Title		
Size	Number	Revision
A3		
Date:	11.14.2025	Sheet of
File:	G:\Druzi\racunalnik\Architecture-BMS\BMS_Schematic	8

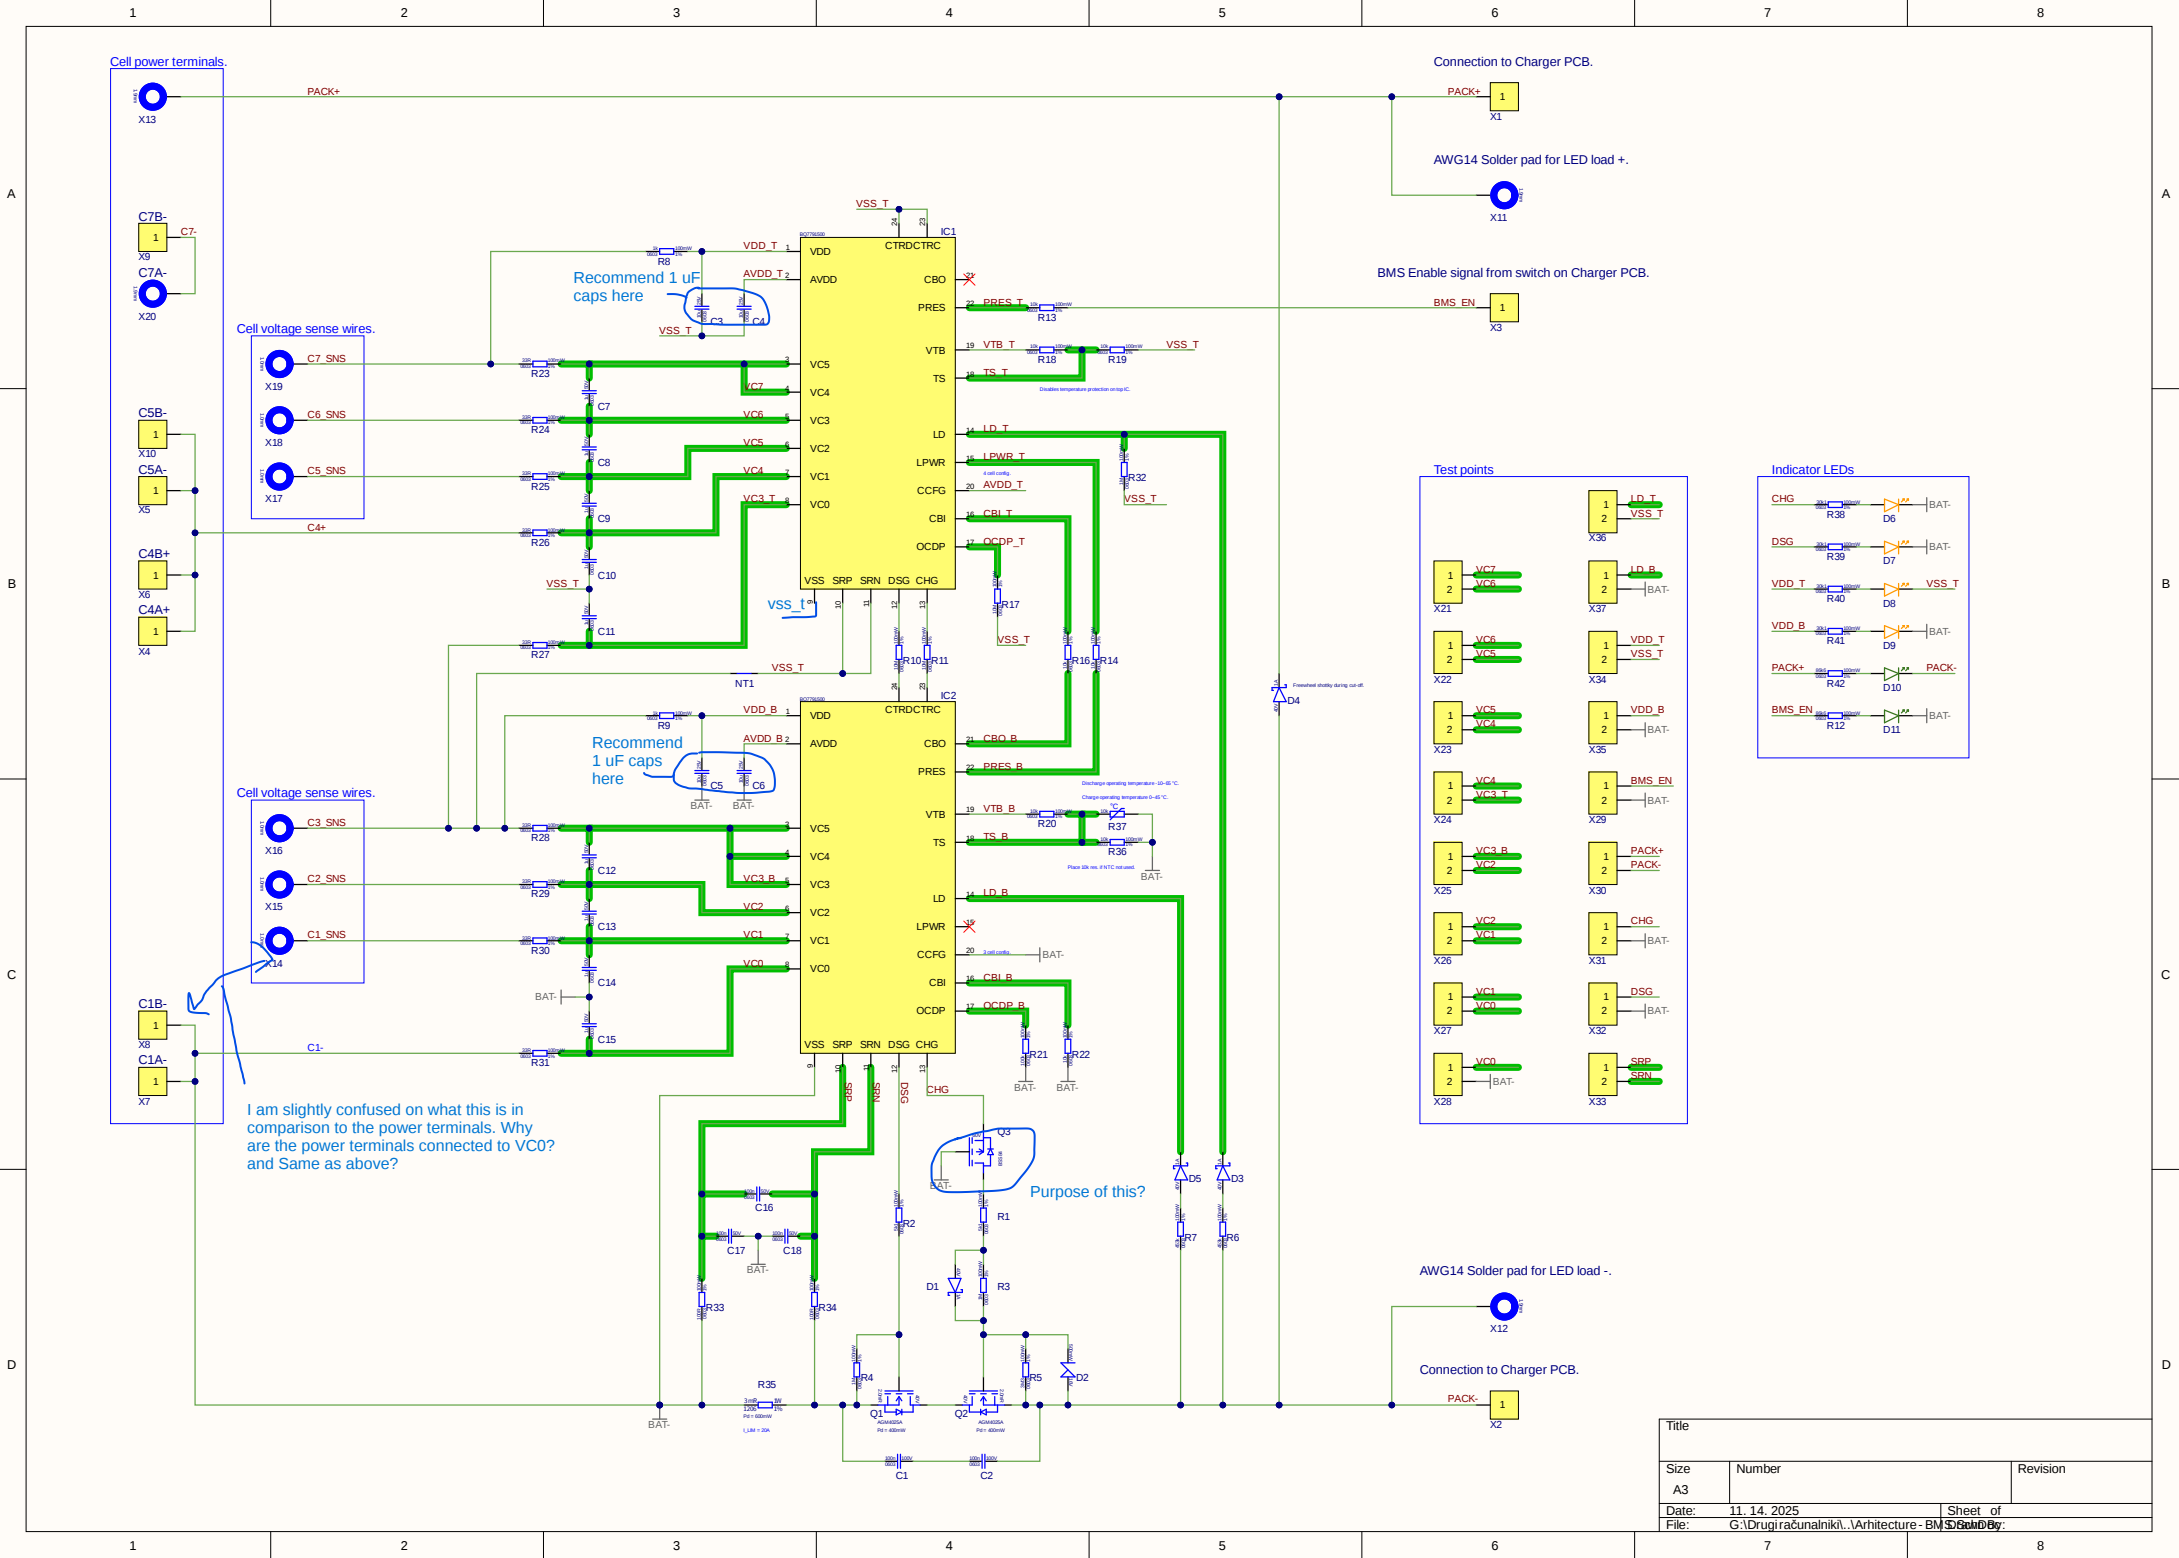
I am slightly confused on what this is in comparison to the power terminals. Why are the power terminals connected to VC0? and Same as above?

Recommend 1 uF caps here

Recommend 1 uF caps here

Purpose of this?
